Report of Geotechnical Engineering Evaluation

Proposed Multifamily Development
Venetucci Boulevard at South Academy Boulevard
Colorado Springs, Colorado

October 11, 2024

PSI Project 05322879

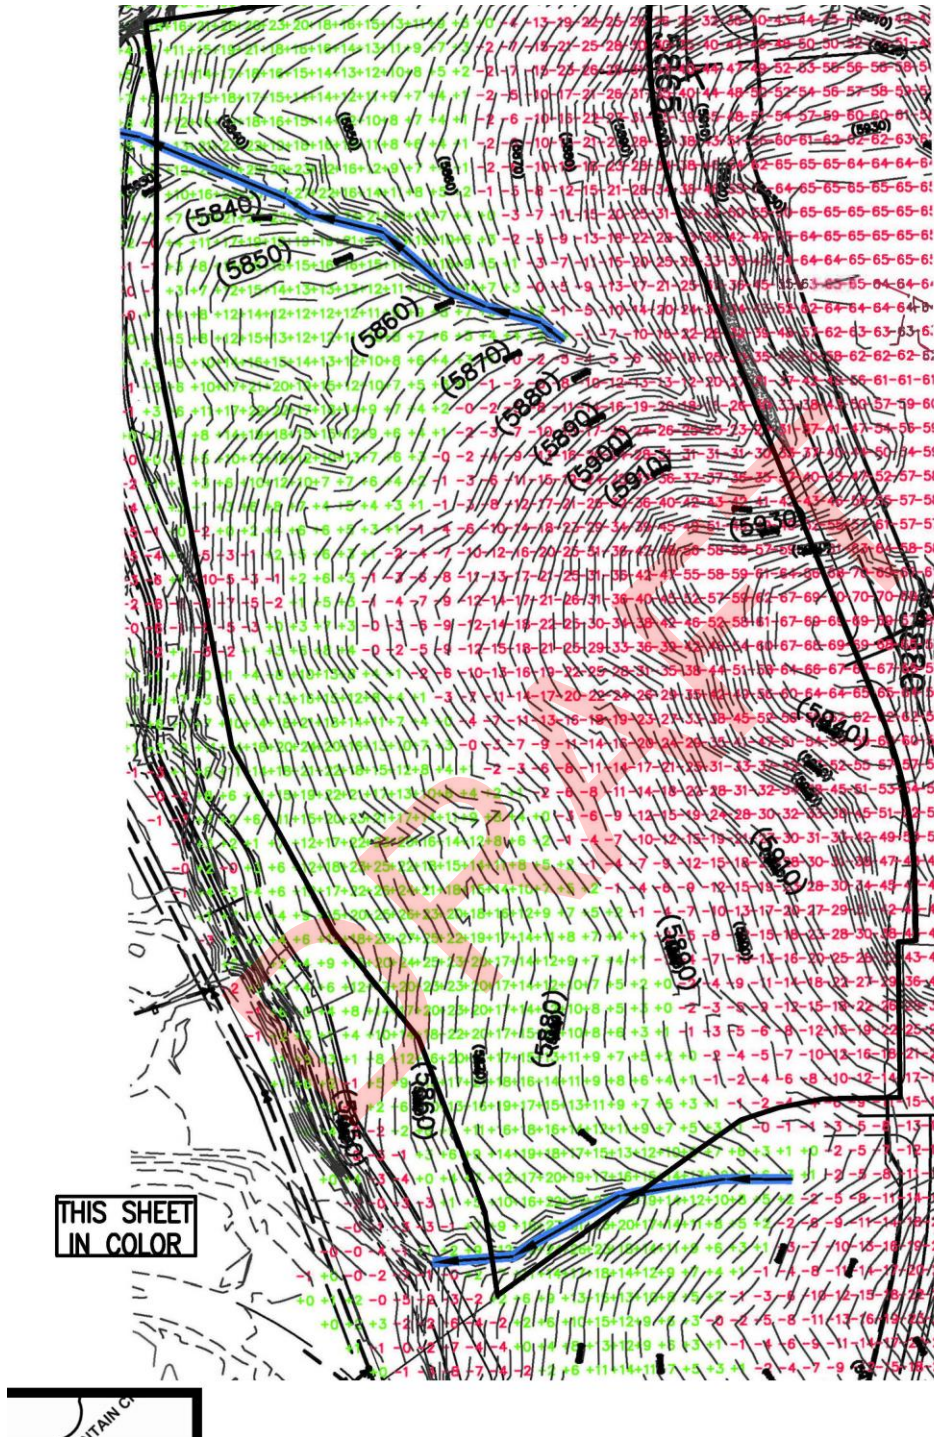
please update to
meet County Code
requirements of
Section 8.4.9 and
those of the ECM

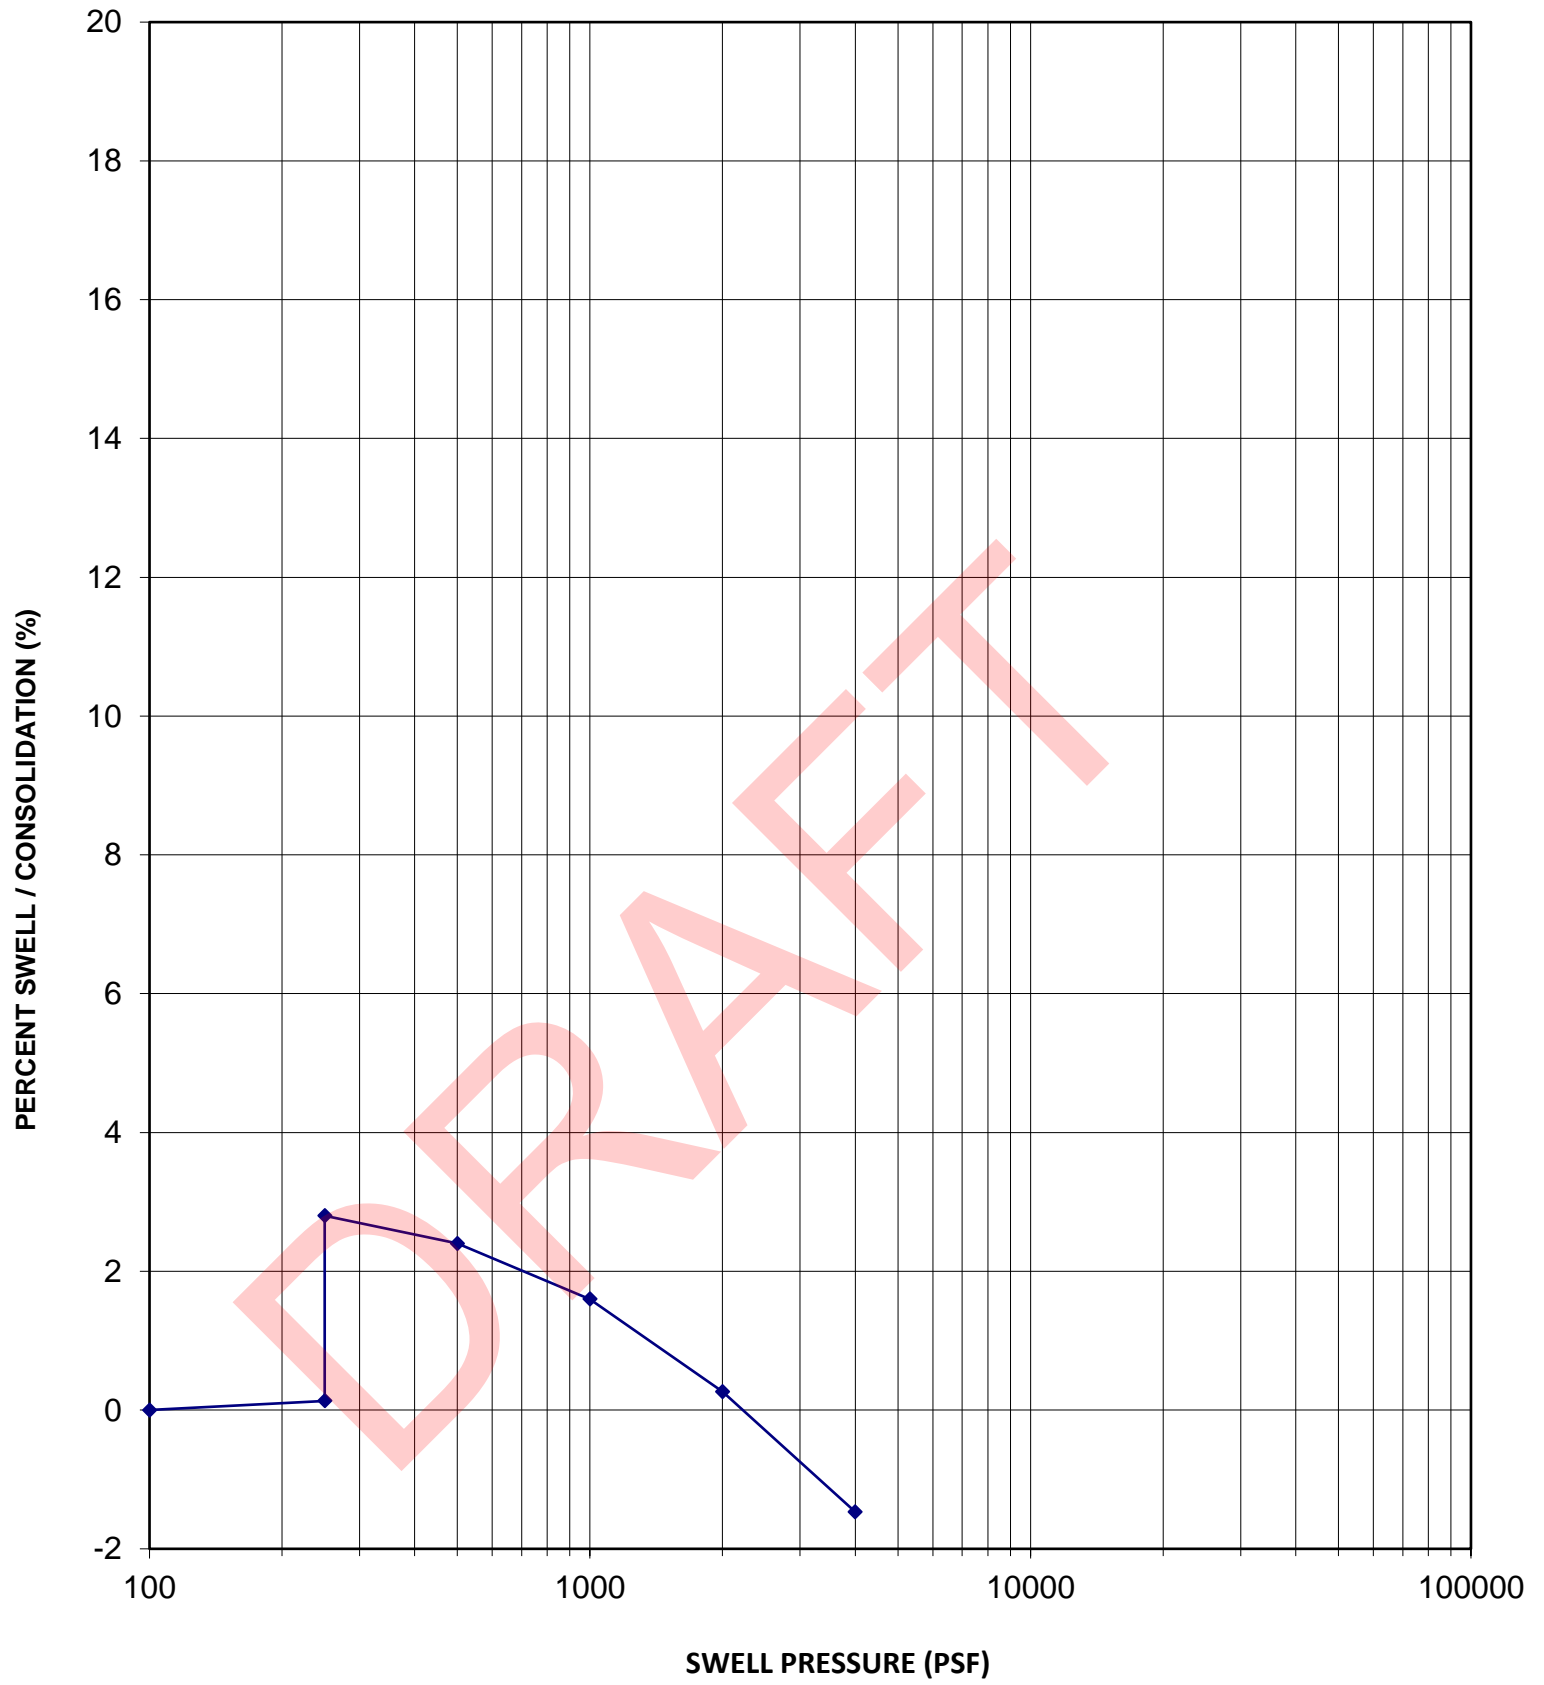
groundwater boring results include

TRes Venetucci Multifamily	JOB NO.	5322879
	SWELL - CONSOLIDATION TEST	FIGURE NO.	0

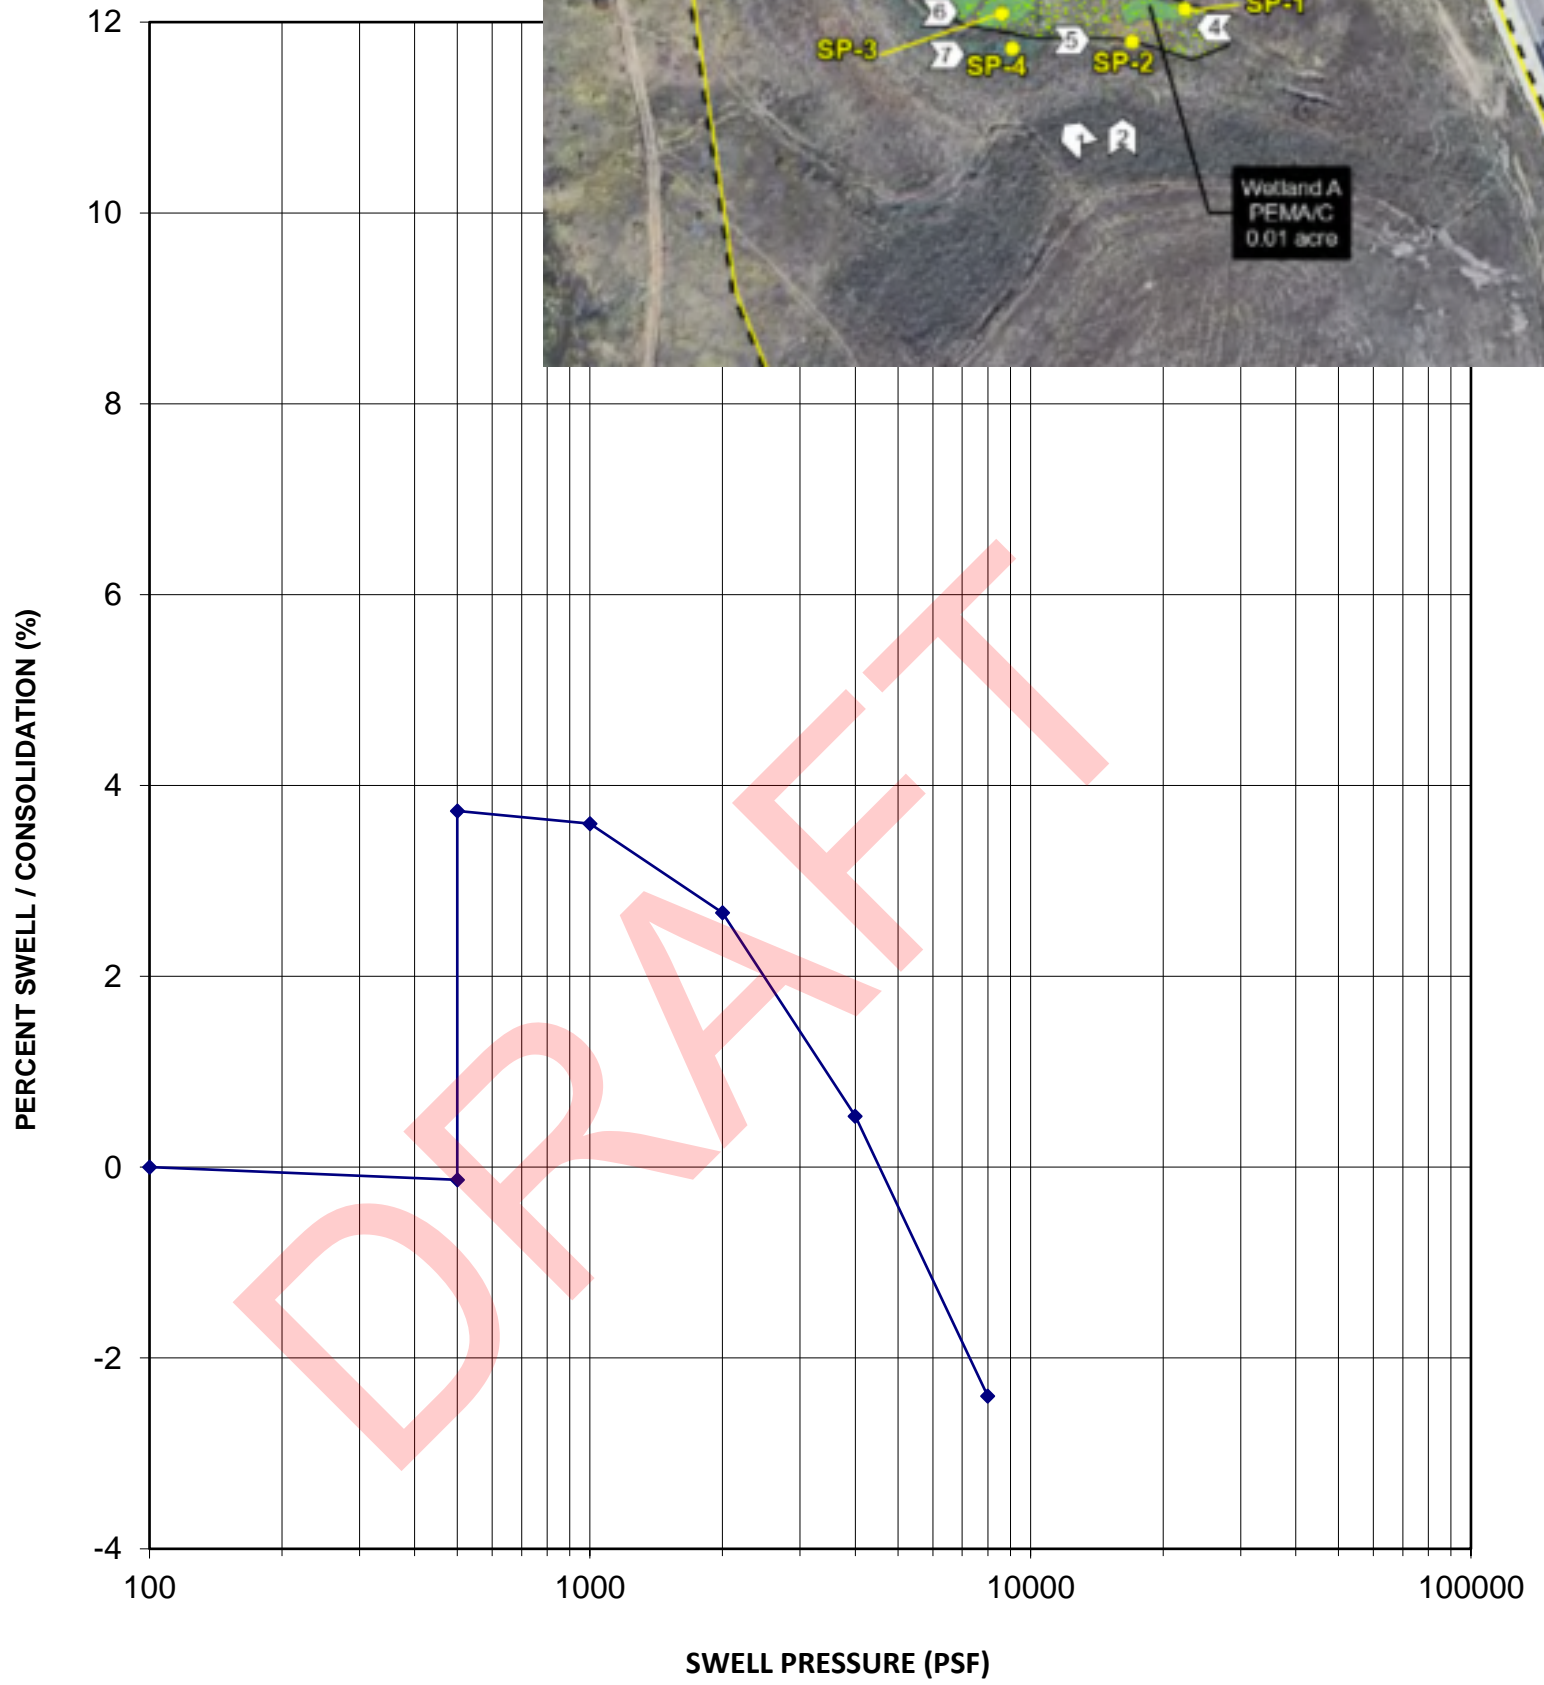
hazards shall be mapped and mitigation method identified

Provide a map of the site with the constraints and hazards identified
